Minutes of the Regular Meeting of the
Review Committee
City of Plantation, Florida
Held October 26, 2021

- a. PP21-0042: CONSIDERATION OF A REQUEST FOR APPROVAL OF SITE PLAN, ELEVATION, AND LANDSCAPE PLAN FOR PUBLIX SUPERMARKET. THE PROPERTY IS LOCATED AT 591 S. UNIVERSITY DRIVE AND ZONED M-PM (MIXED USE – PLANTATION MIDTOWN).**

b. PP21-0044: CONSIDERATION OF A REQUEST FOR APPROVAL OF SITE PLAN, ELEVATION, AND LANDSCAPE PLAN FOR 201 S STATE ROAD 7 BUILDING. THE PROPERTY IS LOCATED AT 201 S STATE ROAD 7 AND ZONED B-HC (GATEWAY – HYBRID COMMERCIAL).

c. PP21-0045: CONSIDERATION OF A REQUEST FOR APPROVAL OF SITE PLAN, ELEVATION, AND LANDSCAPE PLAN FOR UM PLANTATION ANNEX. THE PROPERTY IS LOCATED AT 8100 SW 10 STREET AND ZONED OP-P (OFFICE PARK - PLANTATION).

Site Data Table:

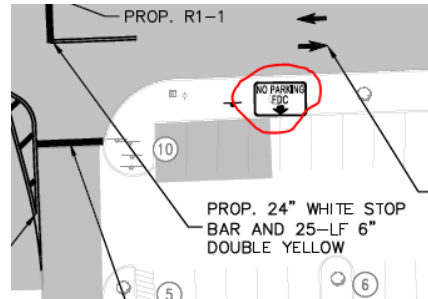
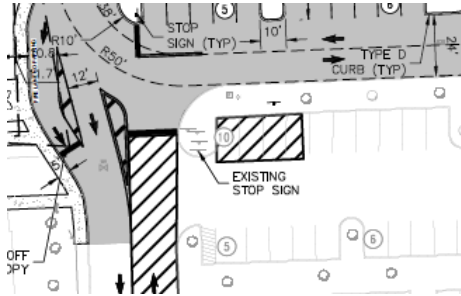
13. Provide updated site data to include this proposal for the overall Cornerstone Master Plan.
14. The parking information for the office park should be included in detail on the site data table. This information has been provided in the letter of intent.
15. As previously discussed, please provide a floor plan for each floor of the main facility. This will allow staff to better evaluate the appropriate parking ratios for the non-medical areas.

C-400

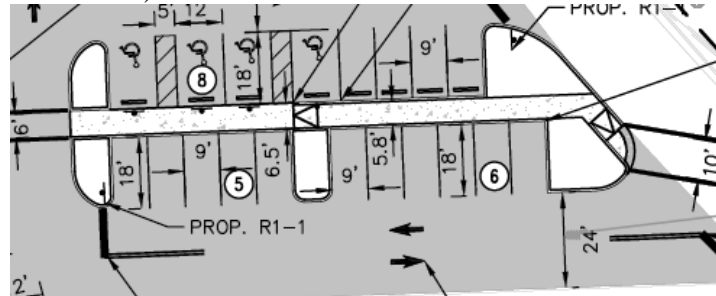
18. Where the new parking spaces are 18-feet in depth, add wheelstops at the 16-foot mark (Section 27-121(i)(1) and Table 121-1).
